SUBJECT: DAVIS-BESSE NUCLEAR POWER STATION, UNIT 1 - STAFF ASSESSMENT OF INFORMATION PROVIDED PURSUANT TO TITLE 10 OF THE *CODE OF FEDERAL REGULATIONS* PART 50, SECTION 50.54(f), SEISMIC HAZARD REEVALUATIONS FOR RECOMMENDATION 2.1 OF THE NEAR-TERM TASK FORCE REVIEW OF INSIGHTS FROM THE FUKUSHIMA DAI-ICHI ACCIDENT (TAC NO. MF3728)

STAFF ASSESSMENT BY THE OFFICE OF NUCLEAR REACTOR REGULATION

RELATED TO SEISMIC HAZARD AND SCREENING REPORT

DAVIS-BESSE NUCLEAR POWER STATION, UNIT 1

Figure 3.3- 1 Plot of Staff's and Licensee's Base Case Shear-Wave Velocity Profiles for the Davis-Besse site

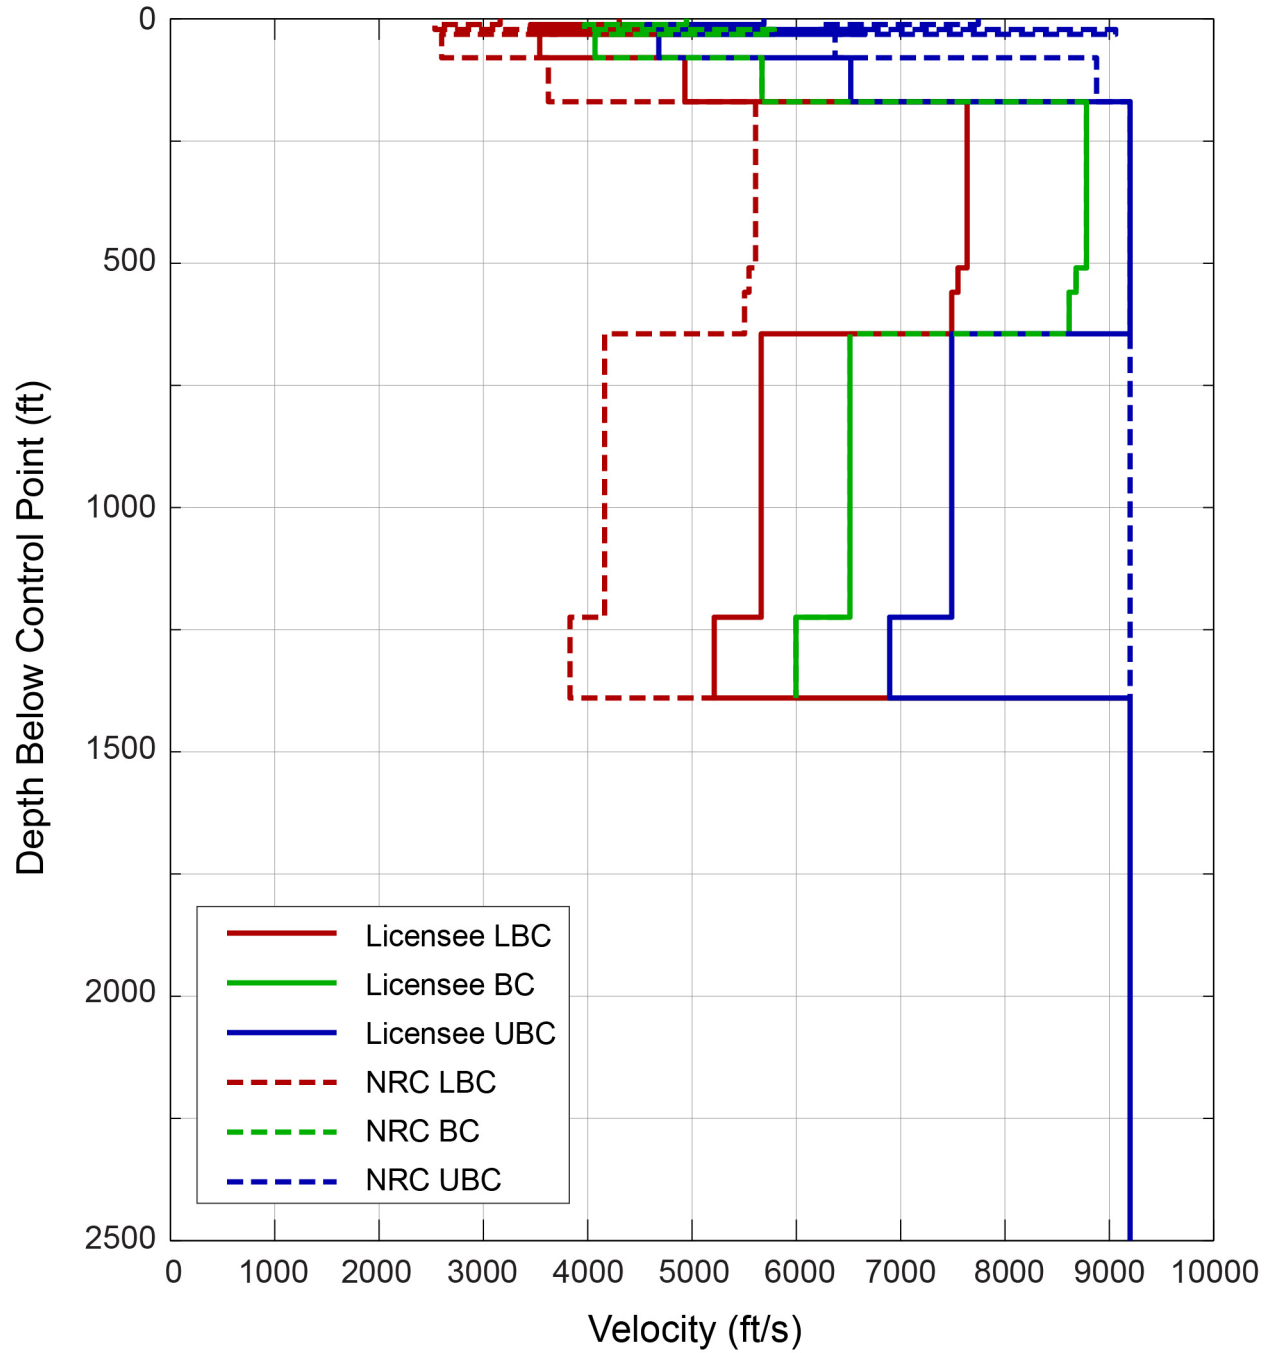
To capture the uncertainty in the shear wave velocity profile due to the limited on-site measurements for the upper layers and use of regional data rather than on-site measurements for the deeper layers, the licensee developed three base case velocity profiles. Table 2-4 of the SHSR provides the licensee's shear-wave velocity profiles (P1, P2, P3). To develop the best estimate for base case shear-wave velocity profile, the licensee set the initial shear-wave velocity at the SSE control point (at an elevation of 540 ft [165 m] MSL) to 4948 ft/s [1508 m/s]. According to the SHSR, based on the well-characterized nature of the flat-lying geologic unit beneath the site, the licensee used a factor of 1.15 (natural-log standard deviation of 0.11) to obtain the upper and lower range velocity profiles. Figure 3.3-1 of this assessment shows the three base case profiles developed by the licensee.

Because the licensee used on-site geophysical measurements and rock cores to estimate the shear wave velocities for the upper rock layers and nearby well log data to estimate the velocities for the deeper layers, the staff adopted the licensee's best estimate base case profile (P1) as its middle base case profile. However, due to the limited amount of on-site geophysical measurements and the use of off-site well log data, the staff used a natural-log standard deviation of 0.35, instead of the licensee's value of 0.11, to develop its lower and upper velocity profiles. The licensee used a lower standard deviation due to the generally flat lying geologic units and the availability of nearby well log data; however, the staff concluded that a somewhat higher standard deviation was warranted since the closest well log is 2-3 miles from the site. As a result, as shown in Figure 3.3-1 of this assessment, the NRC staff's lower and upper velocity profiles are farther from the middle or best estimate profile than the licensee's lower and upper profiles. To characterize the dynamic material behavior of the site response profile, the staff used the same approach as the licensee, which is described above in Section 3.3.1 of this assessment.

Figure 3.3- 2 Plot Comparing the Staff's and the Licensee's Median Amplification Functions and Uncertainties for two input loading levels for the Davis-Besse site

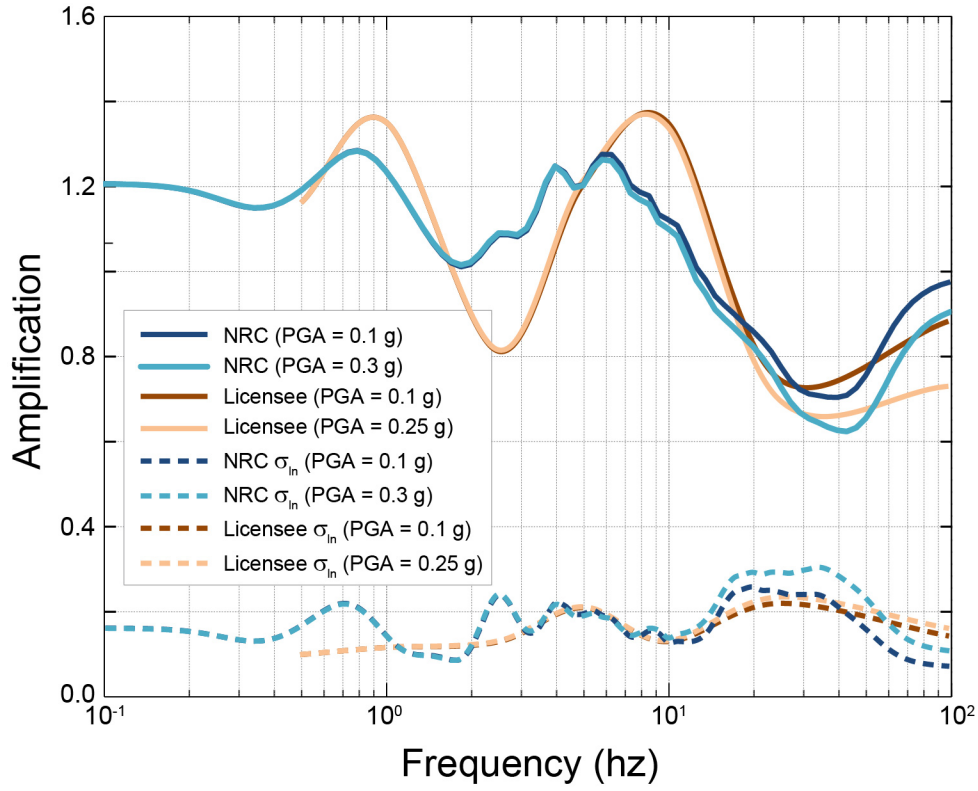
Figure 3.3-2 of this assessment shows a comparison of the NRC staff's and the licensee's median site amplification functions and uncertainties ( $\pm 1$  standard deviation) for two of the eleven input loading levels. As shown in this figure, the licensee's amplification functions peak at around 0.9 Hz and 8.5 Hz, with a trough at 2.5 Hz. The two peaks could approximately be associated with resonance in two columns of firm rock above the crystalline basement with thicknesses of about 1390 ft [424 m] and 170 ft [52 m], respectively. The NRC amplification functions are on average slightly lower than those of the licensee, with resonance frequencies shifted to lower values. The differences in amplification function values are mainly due to

differences in the choice of velocity profiles rather than in differences between the licensee and NRC analysis methods.

Figure 3.3-2 of this assessment shows a comparison of the NRC staff's and the licensee's median site amplification functions and uncertainties ( $\pm 1$  standard deviation) for two of the eleven input loading levels. The amplification functions are highest at frequencies of less than 1 Hz and decrease with increasing frequency. Amplification functions calculated by the NRC staff and the licensee are similar, however uncertainties are higher for the staff's profiles. This is due to the greater epistemic uncertainty in the staff's kappa values and damping parameters.

Figure 3.3-3 Plot Comparing the Staff's and the Licensee's Mean Control Point Hazard Curves at a Variety of Frequencies for the Davis-Besse site

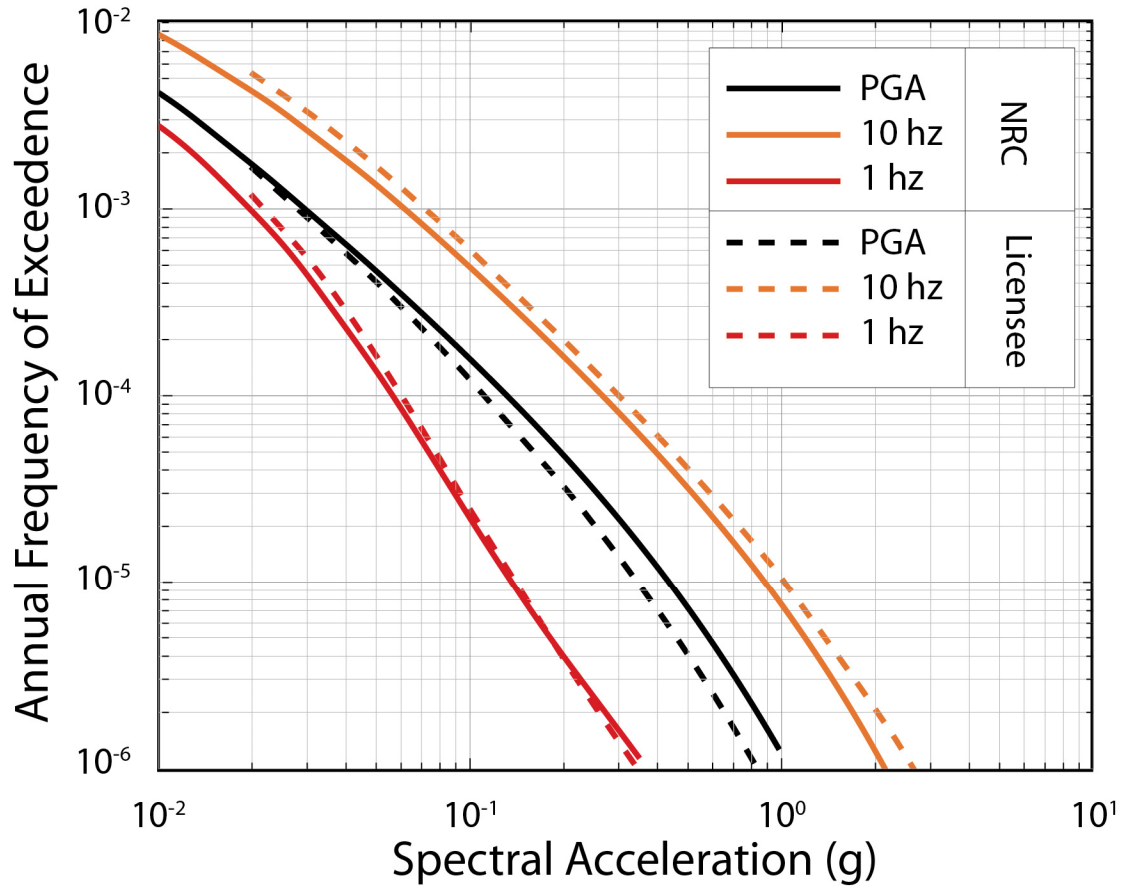
The licensee's approach to modeling the subsurface rock properties and their uncertainty results in similar site amplification factors to those produced by the NRC staff. As shown in Figure 3.3-3 of this assessment, minor differences in site amplification and uncertainty have a very minor impact on the control point seismic hazard curves and the resulting GMRS, discussed below. Appendix B of the SPID provides guidance for performing site response analyses, including capturing the uncertainty for sites with less subsurface data; however, the guidance is neither entirely prescriptive nor comprehensive. As such, various approaches in performing site response analyses, including the modeling of uncertainty, are acceptable for this application.

Figure 3.4-1 Comparison of the Staff's GMRS with Licensee's GMRS and the SSE for the Davis-Besse site

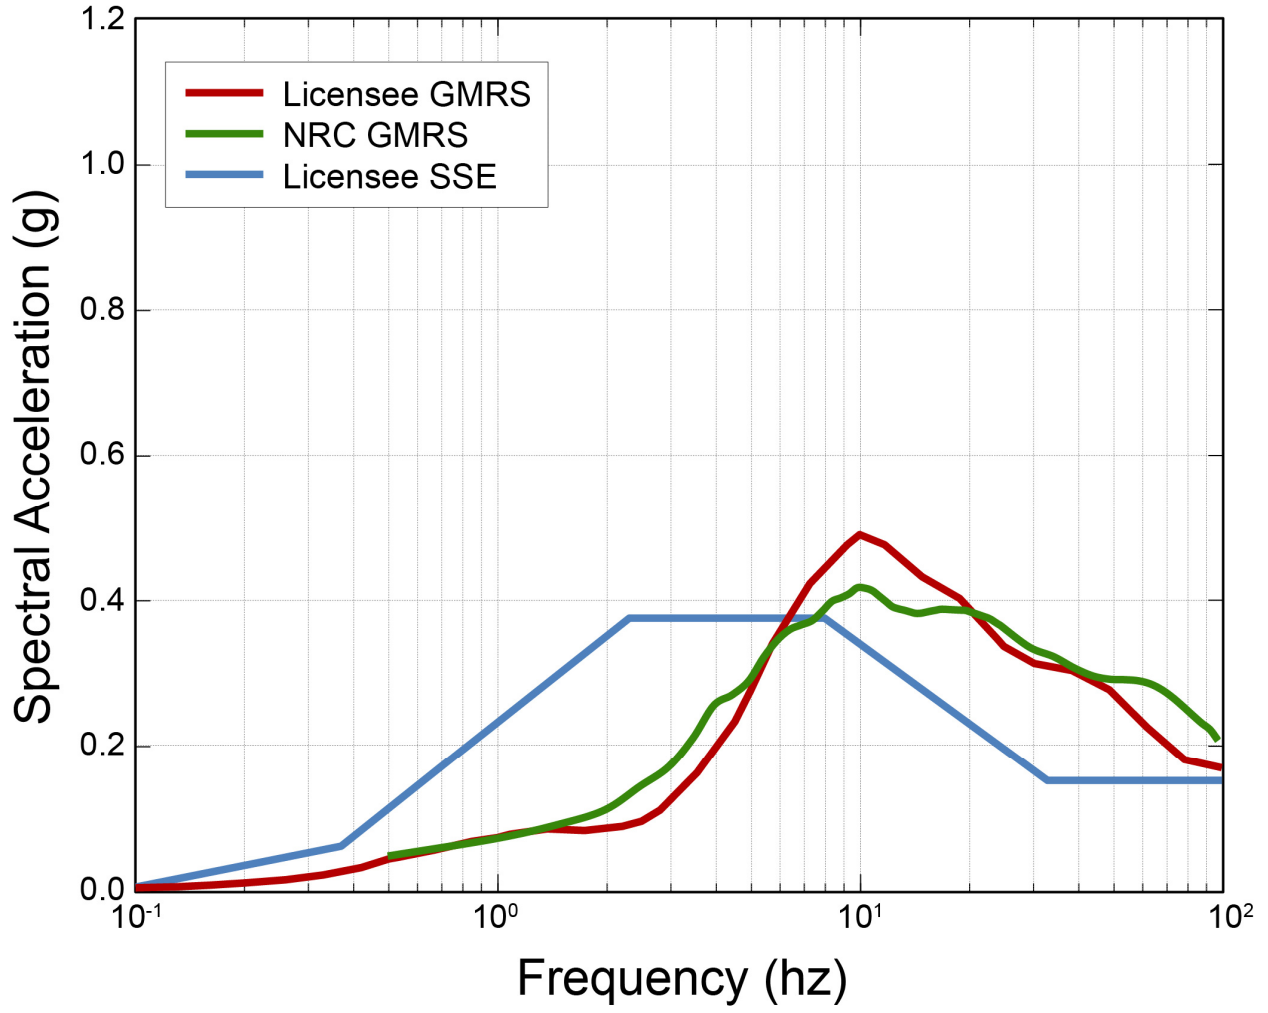
The NRC staff independently calculated  $10^{-4}$  and  $10^{-5}$  UHRS using the results of its confirmatory PSHA and site response calculations, as described in Sections 3.2 and 3.3 of this staff assessment, respectively. Figure 3.4-1 of this staff assessment shows a comparison of the GMRS determined by the licensee to that determined by the NRC staff.

As shown in Figure 3.4-1, the licensee's and NRC staff's GMRS shapes are generally similar with the peak occurring at similar frequencies. The licensee's GMRS is higher than the NRC staff's confirmatory analysis at frequencies between 6 and 20 Hz, but lower elsewhere. As described above in Section 3.3, the NRC staff concludes that these minor differences over this frequency range are primarily due to the differences in the site response analyses performed by the licensee and staff.

50.54(f) letter. The NRC staff performed both a PSHA and site response confirmatory analysis, and achieved results consistent with the licensee's horizontal GMRS. As such, the NRC staff concludes that the GMRS determined by the licensee adequately characterizes the reevaluated hazard for the DBNPS site. Therefore, this GMRS is suitable for use in subsequent evaluations and confirmations, as needed, for the response to the 50.54(f) letter.
